BOARD OF WATER SUPPLY

Subject: Honolulu Board of Water Supply (BWS) Comments on draft "Report to the Thirtieth Legislature, State of Hawaii, 2019, Pursuant to Section 342L-62 Hawaii Revised Statutes, The Third Annual Fuel Tank Advisory Committee Meeting to Study the Issues Related to Leaks of Field-Constructed Underground Storage Tanks at Red Hill Bulk Fuel Storage Facility and Four Other DOD Facilities", Prepared By: State of Hawaii, Department of Health (DOH), Underground Storage Tank Section, dated December 2018

**PURSUANT TO SECTION 342L-62 HAWAII REVISED STATUTES
THE THIRD ANNUAL FUEL TANK ADVISORY COMMITTEE MEETING
TO STUDY THE ISSUES RELATED TO LEAKS OF FIELD-CONSTRUCTED
UNDERGROUND STORAGE TANKS AT RED HILL BULK FUEL STORAGE FACILITY,
AND FOUR OTHER DOD FACILITIES**

Figure 1: Coupon No. 7 viewed from the cut edge shows the corrosion and staining on the backside against the concrete. Remaining wall appears to be about 2 mm or 0.079 inches.

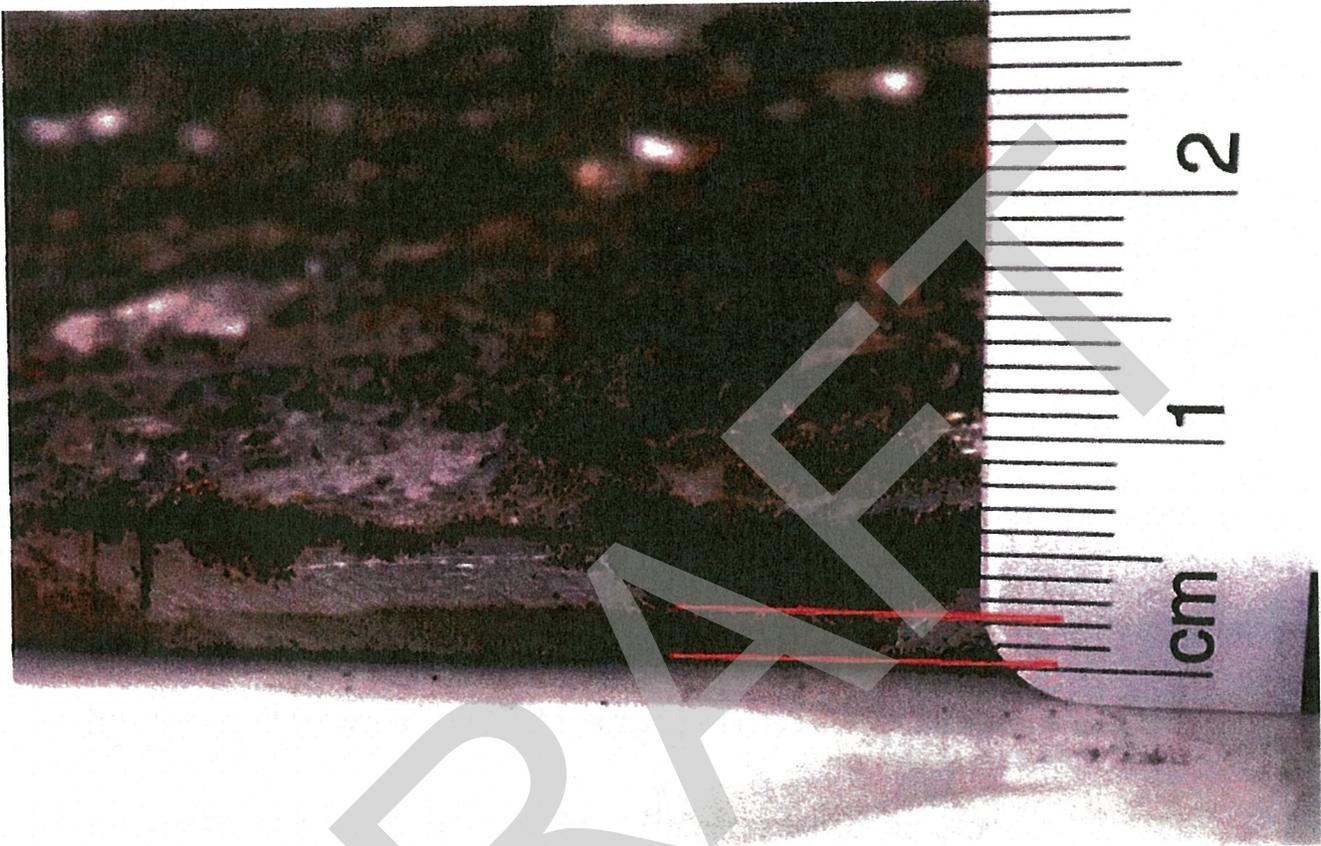
1. Presence of substantial backside corrosion — There were areas of substantial corrosion on the backside (non-fuel wetted side) of the ¼-inch thick steel plate lining the tank (Figure 1, for example).

remaining wall of 0.079-inches (see Figure 1). These are our observations, and we look forward to reviewing the results of the independent testing laboratory for confirmation.
